knitter-switch

Product Change Notification

Products affected: DBS 3001, 3002, 3003, 3004, 3005, 3006, 3007, 3008, 3009, 3010, 3012 with and without suffix „THR“

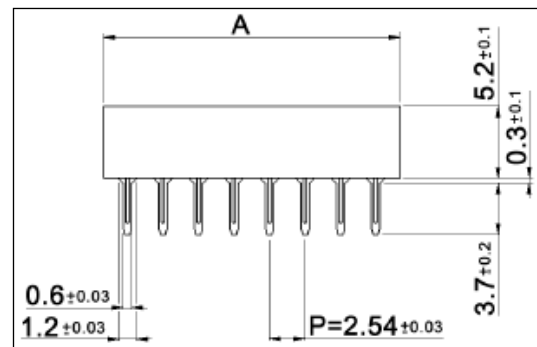
Due to a problem with the document management a change of the part geometry wasn't entered on time into several of the 3000 series data-sheets.

The modification concerns the height of cover, the distance to the PCB surface and the length of terminals.

Until October 2011

From November 2011
